### **Application by Cottam Solar Project Ltd for an Order Granting Development Consent for Cottam Solar Project : Requests for Further Information**

#### **Interested Party Reference number: 20037132 : Deadline 5, Tuesday 27 February 2024.**

## Environmental Statement ES Addendum 21.2: Blyton Park Driving Centre

**Blyton Park,**  
**Solar Farm Acoustic Report Initial Response**

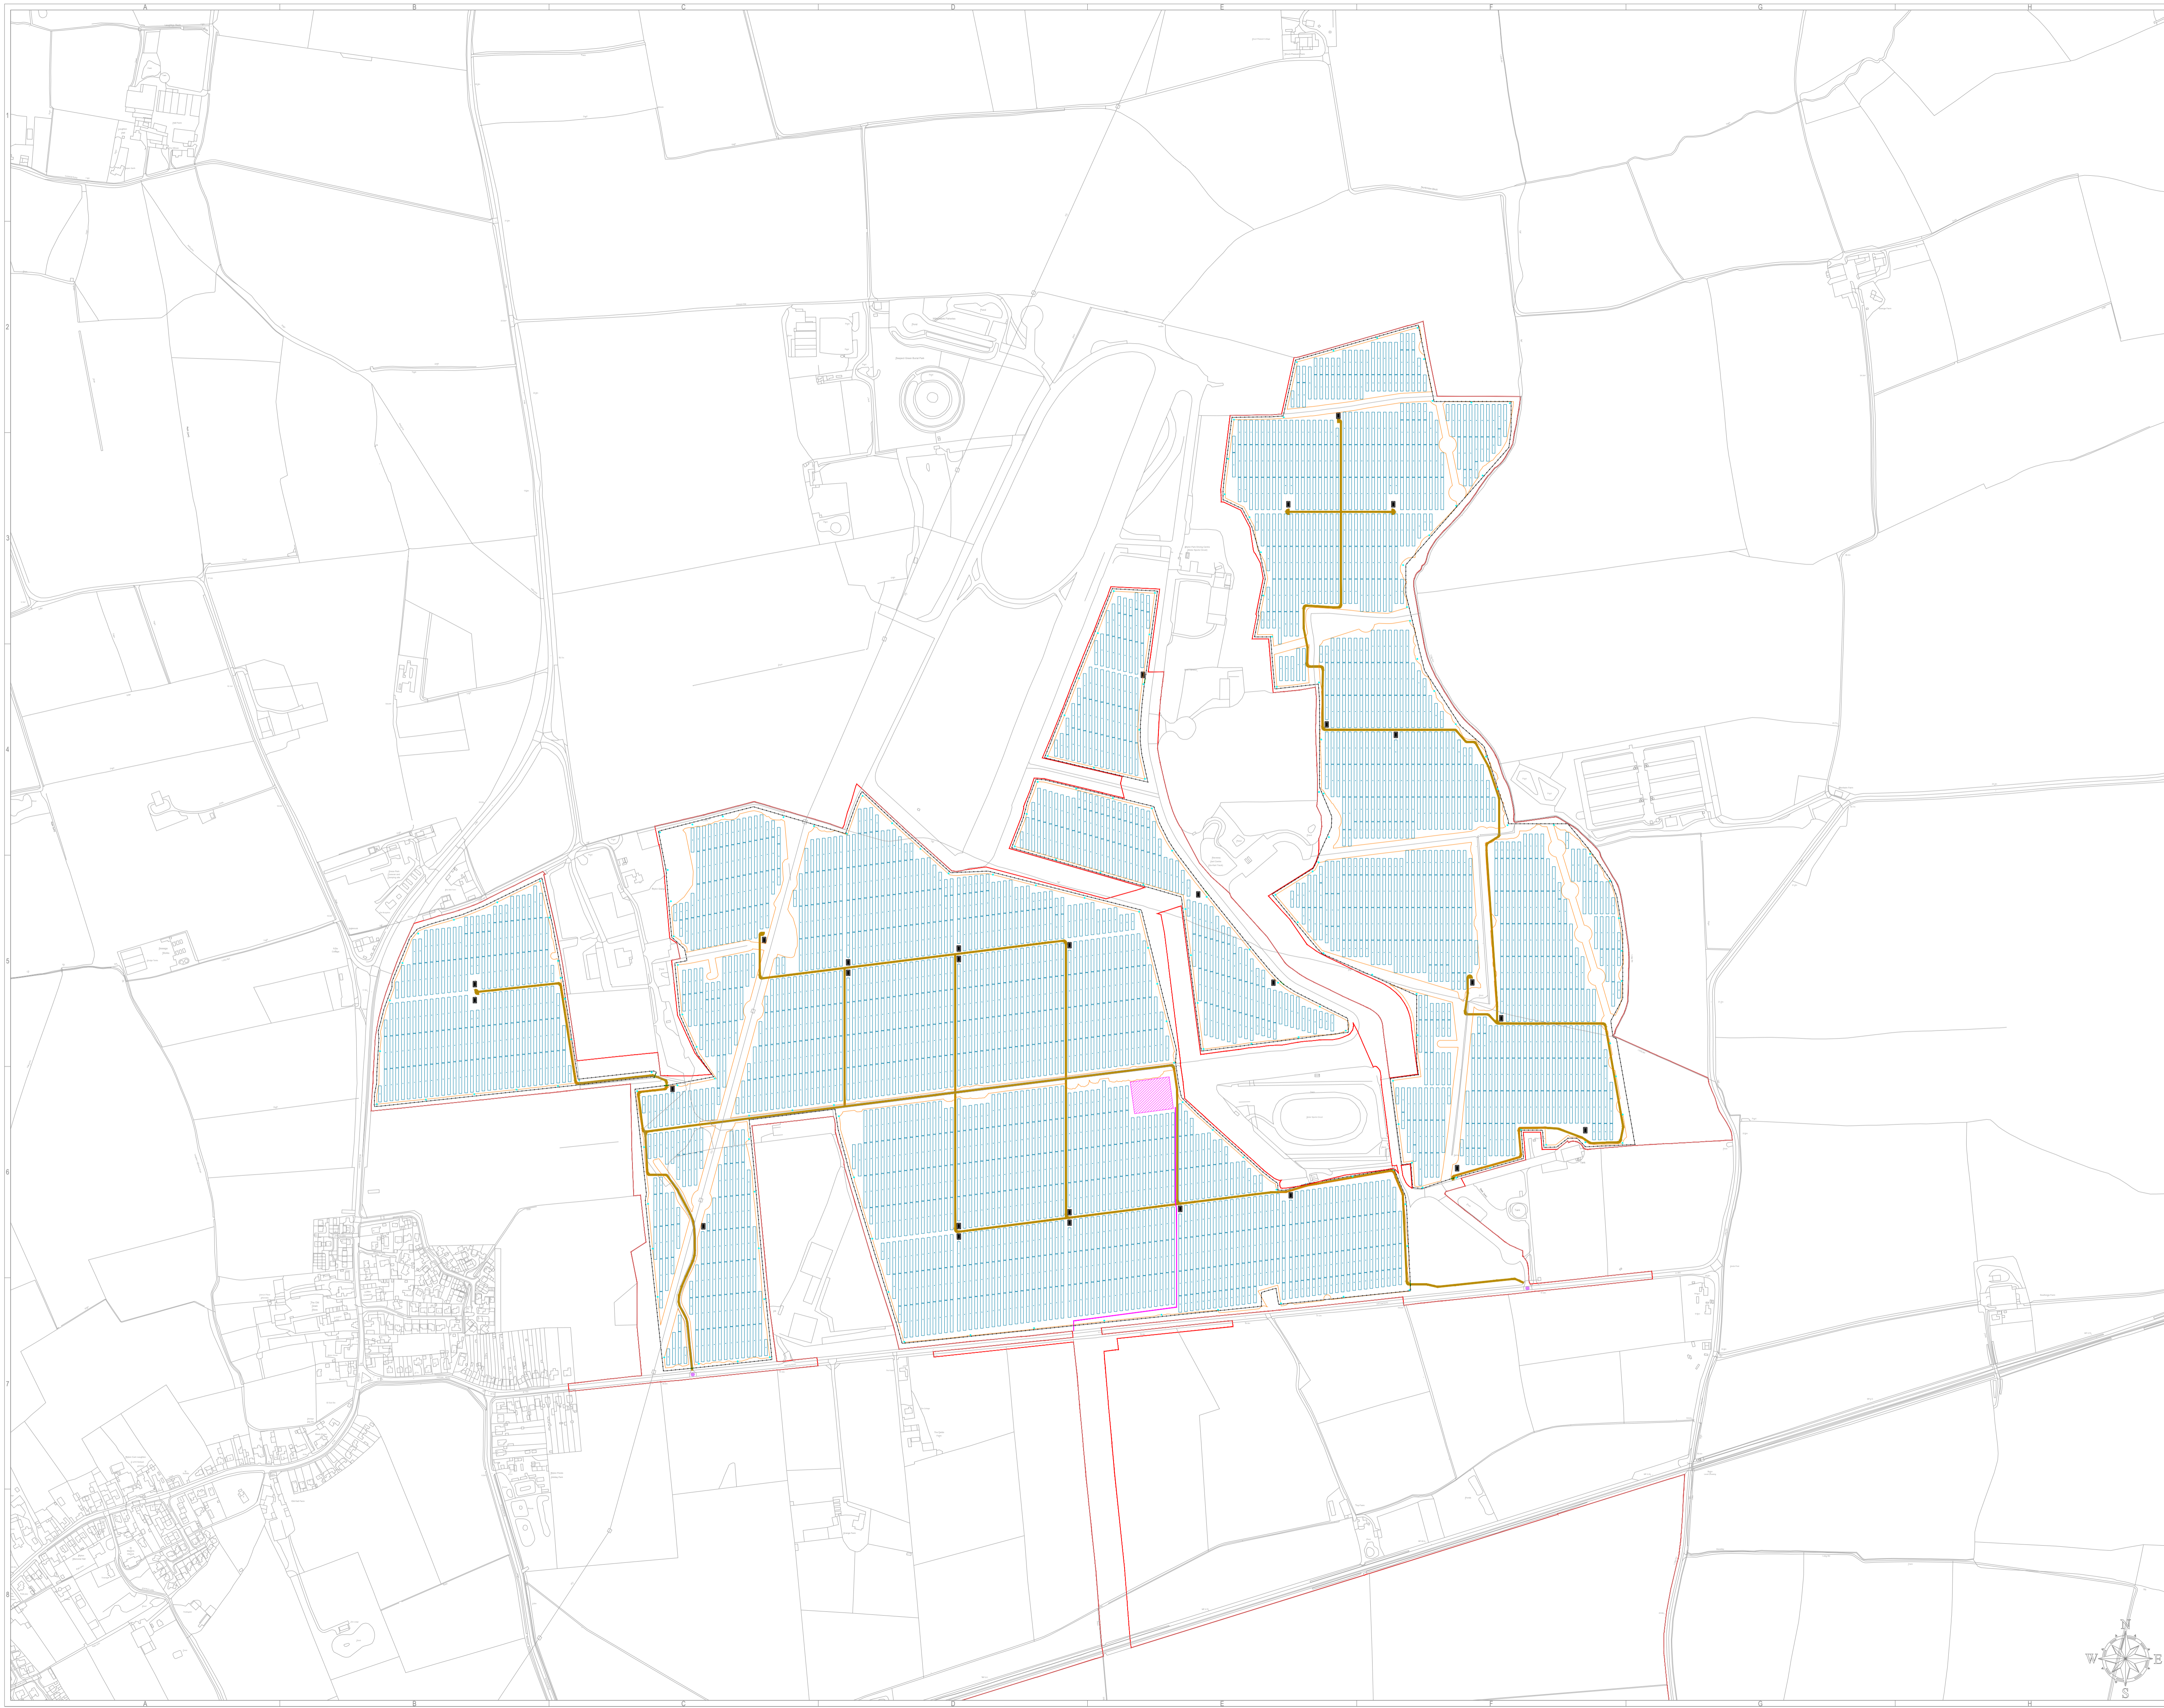
In the circumstances and in the absence of any response from either recognised circuit modellers, it remains the case that Blyton Park/LNT have provided a plan (attached again for ease of reference) that identifies minimum unrestricted run-off areas in respect of the key parts of the driving circuit. These are believed to be the necessary minimum to preserve the existing operating conditions of the circuit and driver safety. This plan still requires, of course, verification by MSUK, to ensure that operating conditions remain acceptable and that the health and safety of drivers using the circuit is suitably. preserved.

The Applicants have not proposed to altered/amend their layout of Solar Panels in any way from that indicated in the attached Illustrative Layout Cottam 3A drawing. The Solar Panels continue to be proposed in extreme proximity to the established high-speed driving circuit, to make them a clear and unequivocal health & safety risk, were they to be installed. The proposed layout remains, therefore, wholly unacceptable in health & safety terms and wholly unacceptable in planning terms, given the potential impact that the current development proposals are likely to have on the very long-established business activities of Blyton Park and it's recognised and positive contribution to the local economy.

**Figure 3.1: Contour Plot showing the Noise Level Contribution for the Fixed Panels**

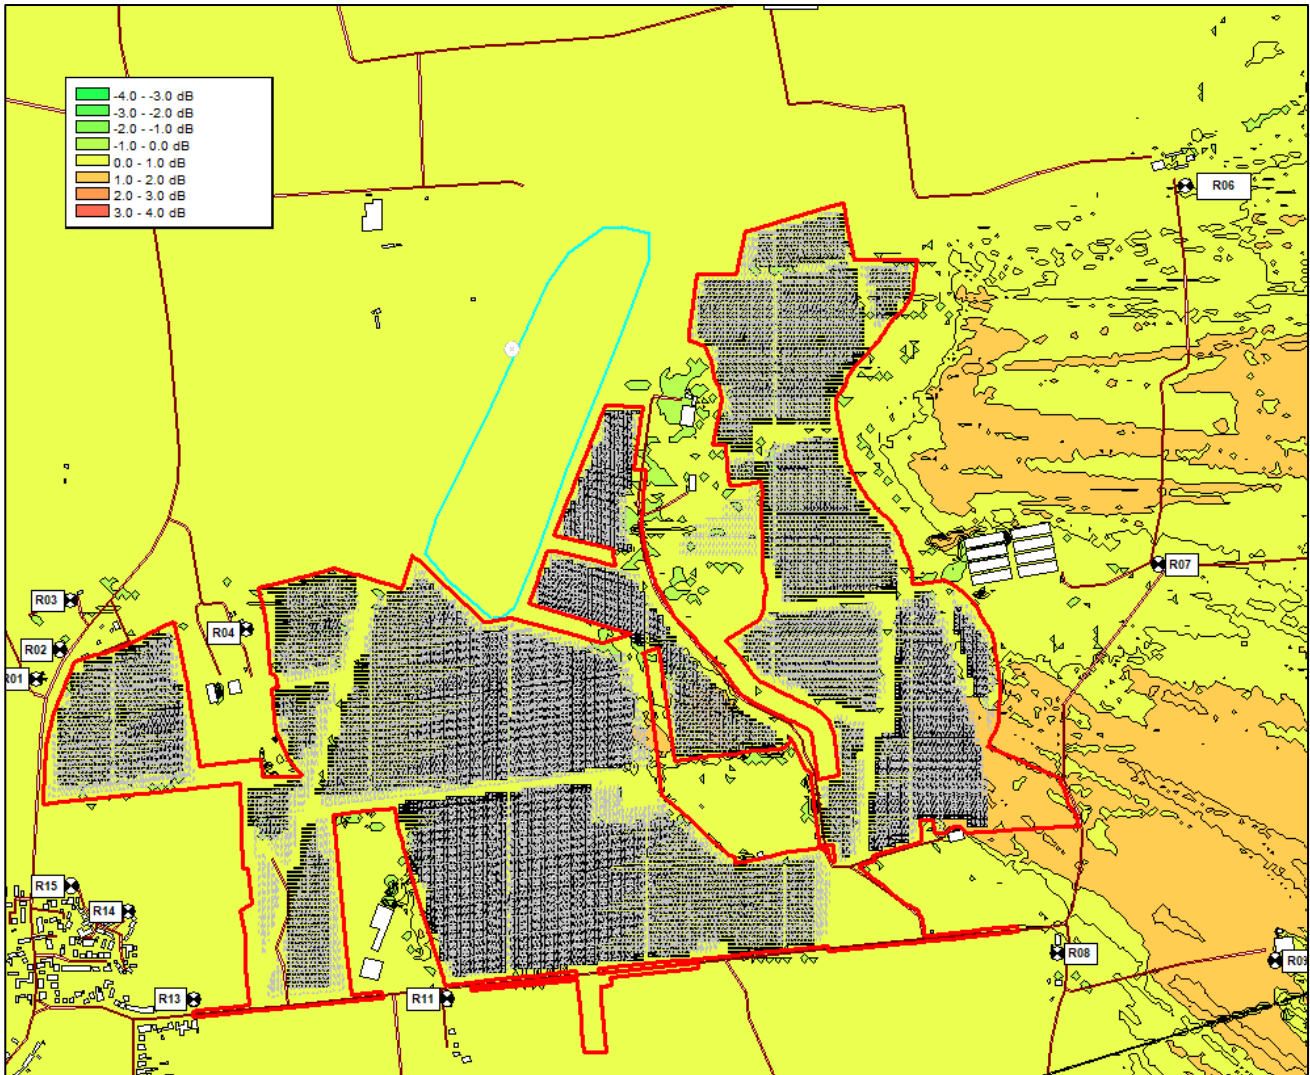
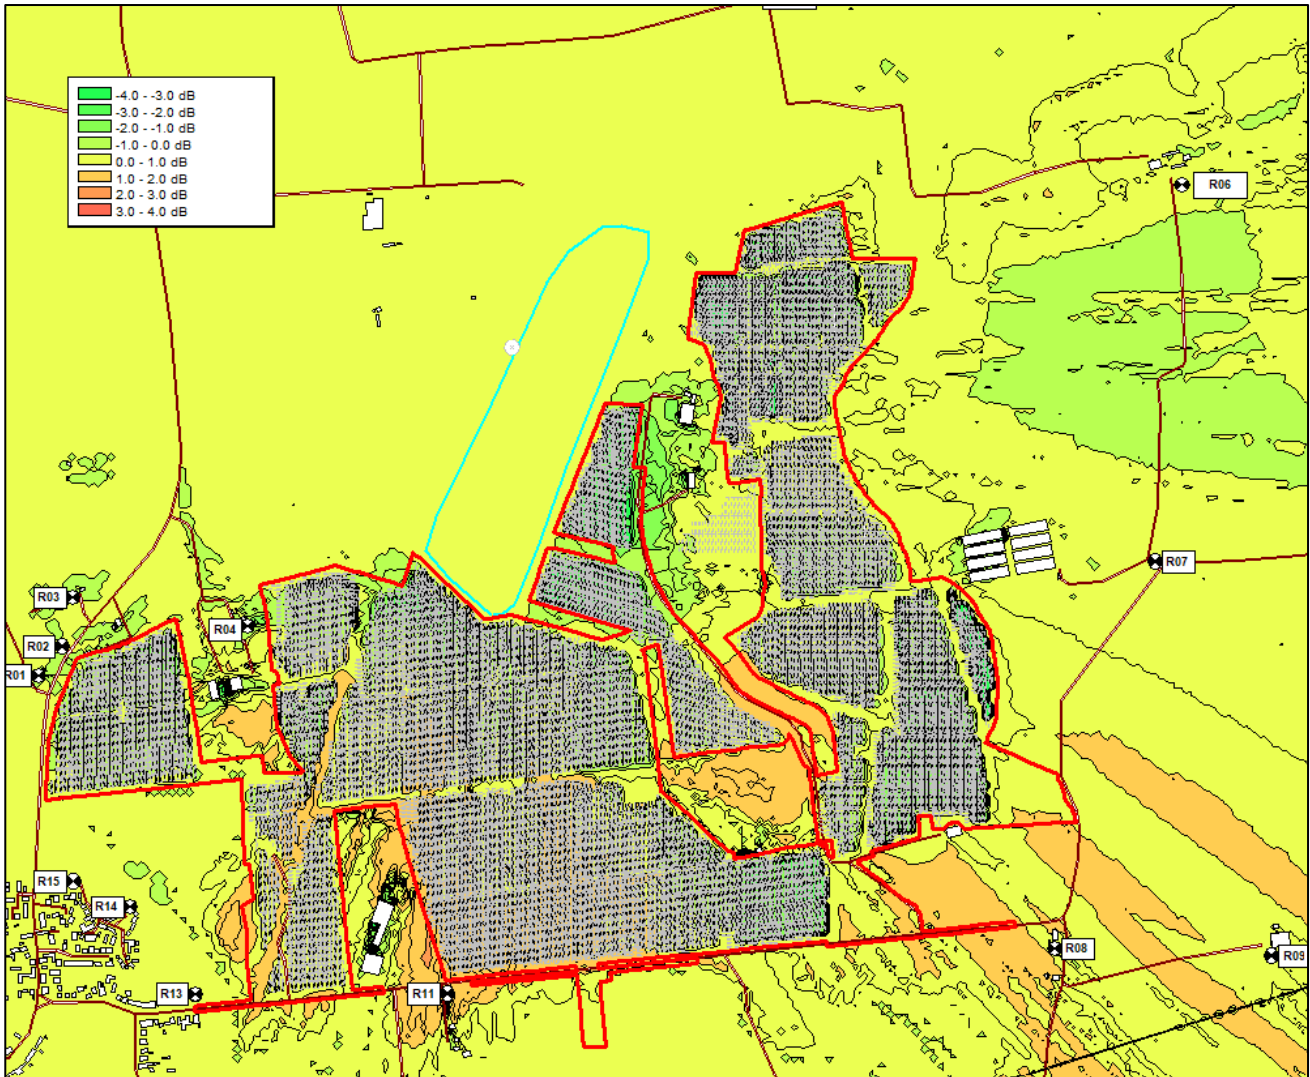
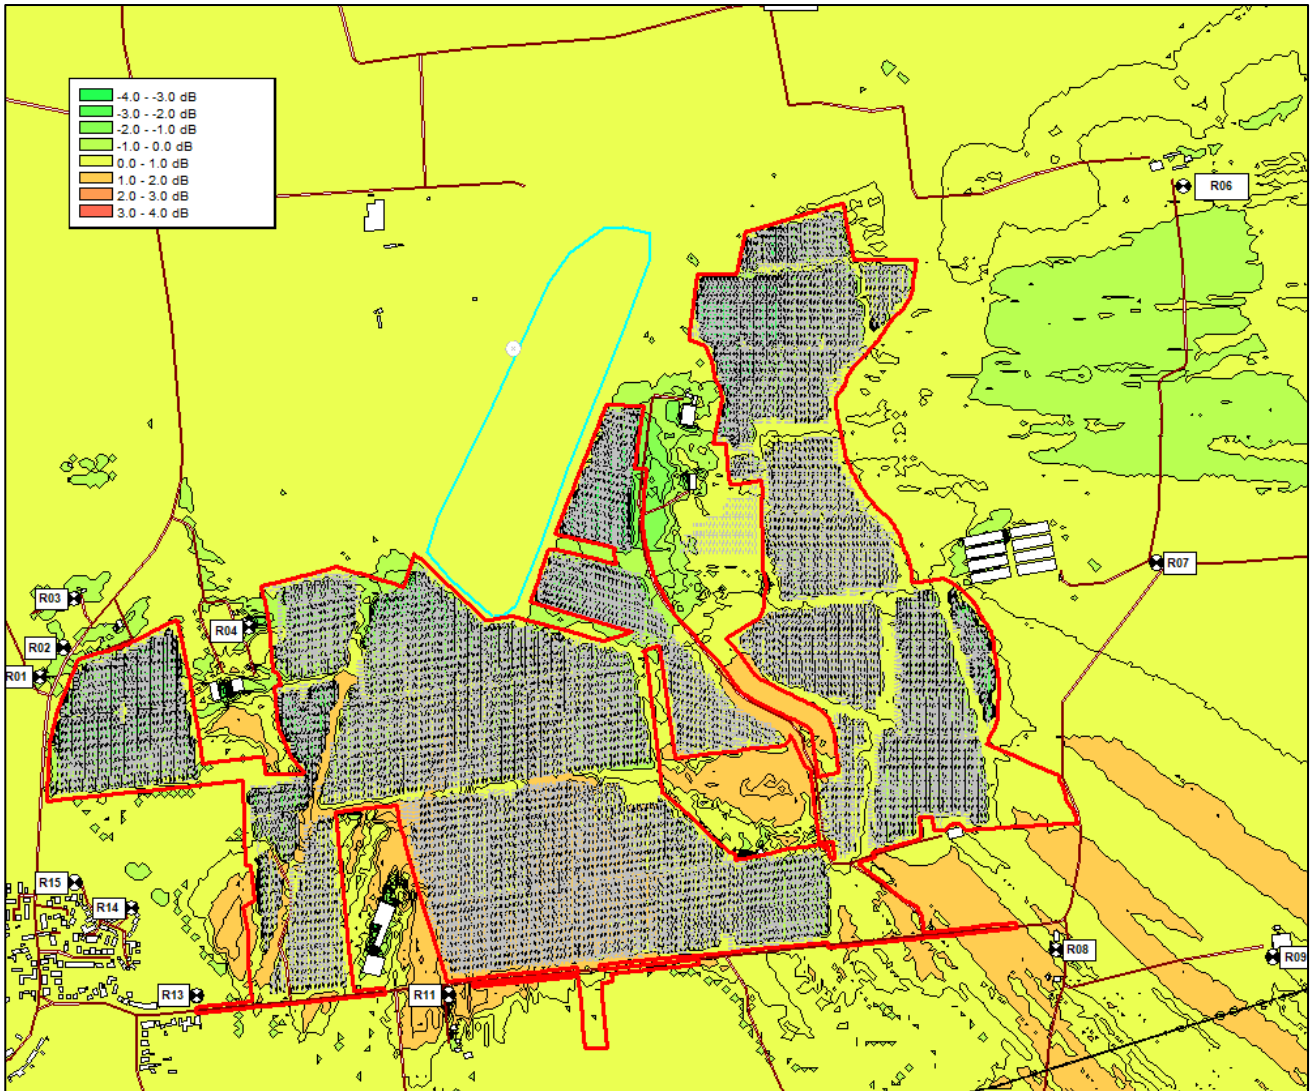
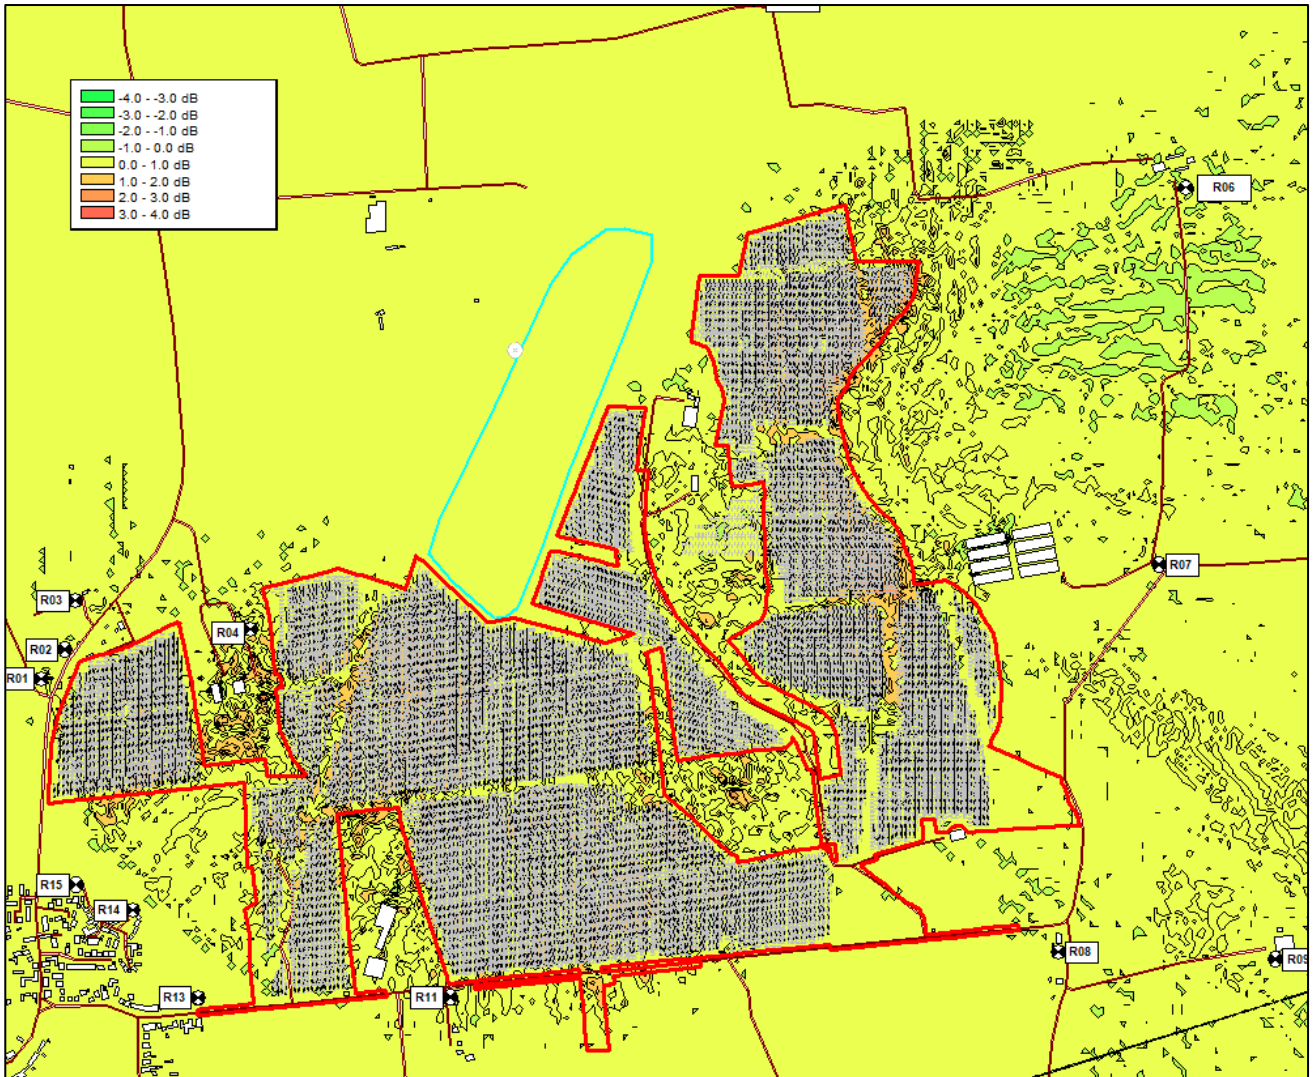
The report does not contain details of all of the calculations being undertaken by the software with separate details of changes to distance decay, barrier effect, reflections etc at each of the measurement positions. This is likely to be part of the nature of using modelling software, but it means that there are not enough details for me to check through all of the calculation procedures and provide some manual verification on concluded predictions. Tetrattech may be able to advise on what detailed outputs are available to enable some manual verification; I am of course happy to take part in further discussions with them.

Clearly there is a large difference between the overall or absolute values of the Tetrattech CadnaA model predictions and those measured or predicted by us as part of the consultancy exercise. I understand that this was of some concern to Blyton Park and while there are not the raw details in the report that enable manual verification, I have attempted to analyse the likely procedures in order to offer an explanation. There does appear to be a possible explanation, which may also have some influence on the accuracy of the comparison of 'with development' and 'without development' sound levels.

As mentioned, there is not the individual detail available in the report for me to verify exactly how the calculations have been undertaken. It would be ideal to have a breakdown of distance decay with/without development, predictions of barrier effect, predictions of reflections etc at each octave frequency band so that the individual differences of each aspect can be viewed, rather than just the overall results given by CadnaA. Again, this may be a limitation of the software instead of a series of manual calculations using spreadsheets or similar. If suitable outputs can be gained from the software, it is likely to need significant sorting to remain readable – the amount of data involved is very large indeed.

Figure 3.1 presents a noise contour plot of the noise level contribution of the deflection of noise from the proposed fixed solar panels, indicating that there is a slight increase of between 1 – 2 dB in certain areas to the east of the racetrack.

Figure 3.2 presents a noise contour plot of the noise level contribution of the deflection of noise from the proposed tracker solar panels at their maximum rotation position facing east. The figure indicates that there is a slight noise level reduction to the east of the racetrack likely due to the screening effect of the panels. A slight increase in noise levels to the southeast and southwest of the racetrack is also shown.

Figure 3.3 presents a noise contour plot of the noise level contribution of the deflection of noise from the proposed tracker panels at their maximum rotation position facing west. Again, the figure indicates a slight improvement in noise levels to the east of the racetrack, likely due to screening and a slight increase in noise levels to the southeast and southwest of the racetrack.

Figure 3.4 presents a noise contour plot of the noise level contribution of the deflection of noise from the proposed tracker panels in their horizontal position. A similar, less pronounced pattern is produced to that for the tilted tracker panels shown in figures 3.2 and 3.3 above.
